DEPARTMENT OF ENVIRONMENTAL MANAGEMENT
DIVISION OF LAND RESOURCES
INDIVIDUAL SEWAGE DISPOSAL SYSTEM APPLICATION (2/79)

8706042

SITE LOCATION
 STREET: **OPP POLE 105 NOOSENECK HILL RD. COVENTRY**

PROPOSED SEWAGE DISPOSAL SYSTEM FOR PETER BORGHESENI		
SCALE 1" = 30'	APPROVED BY AP 28 LOT 23	DRAWN BY TST
DATE JAN 1987		REVISED
COVENTRY, RHODE ISLAND		
BRISTOL ASSOCIATES	DRAWING NUMBER

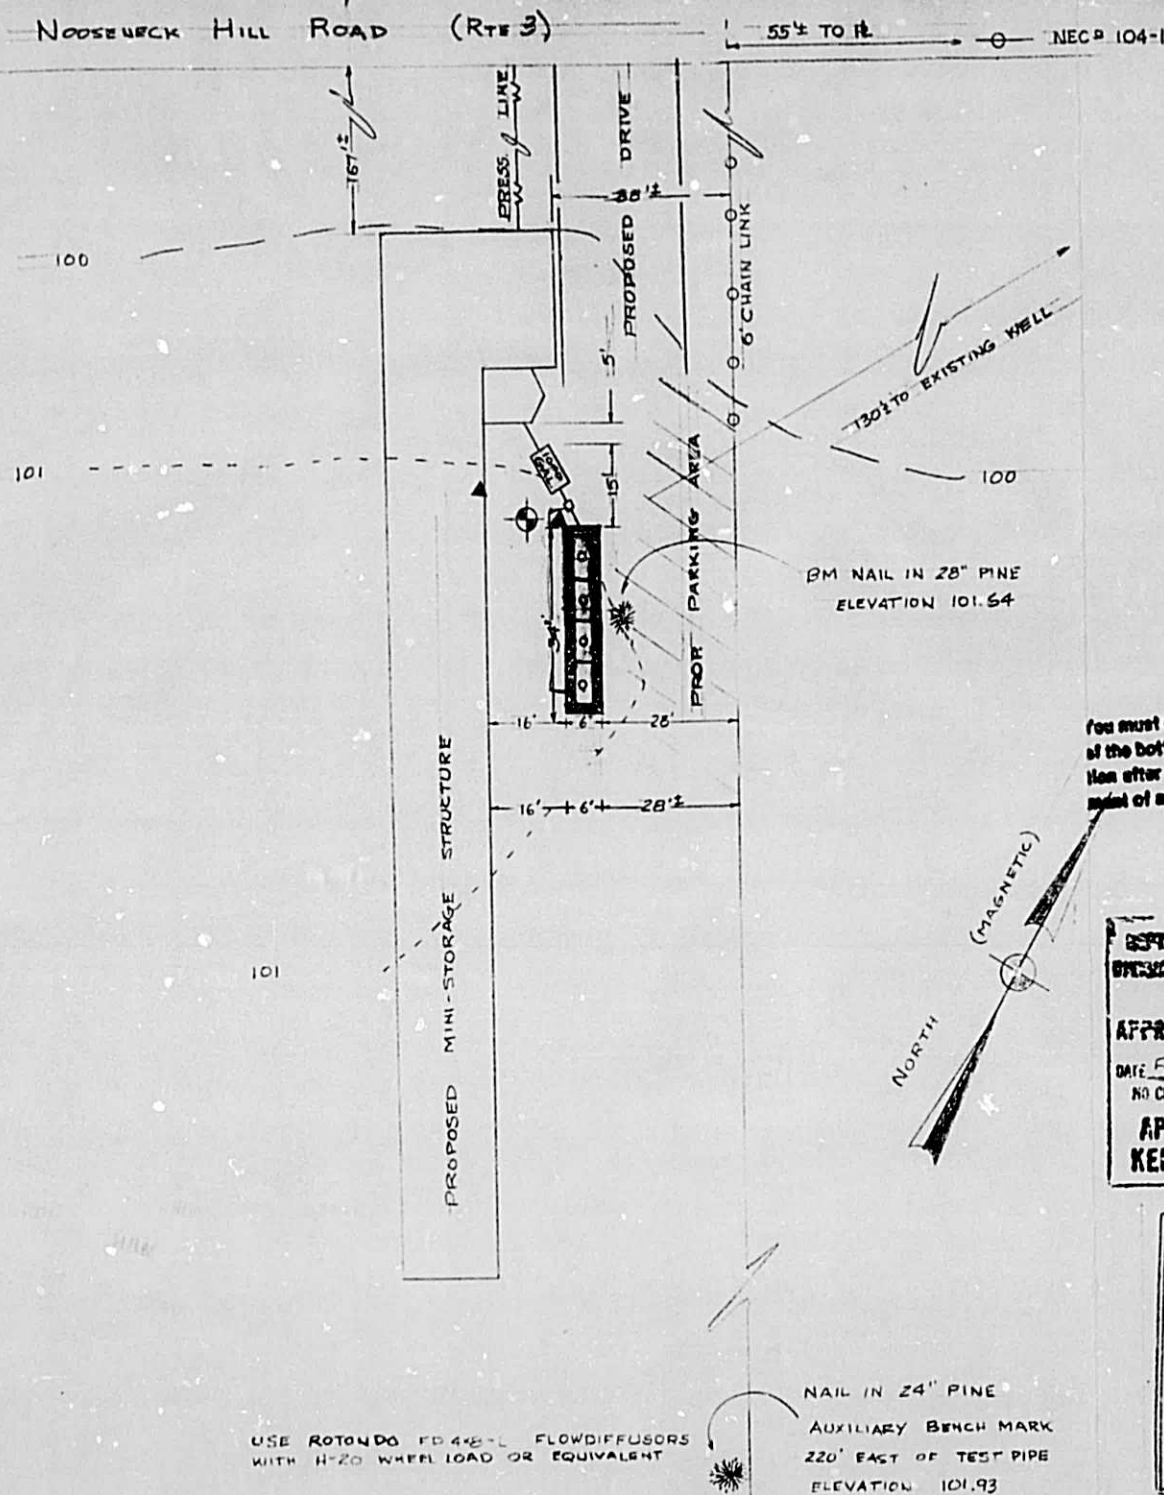
The following cited items are discrepancies revealed upon the review of subject application:

- Re submit Application w/ GWT card. (\$25.00 fee)
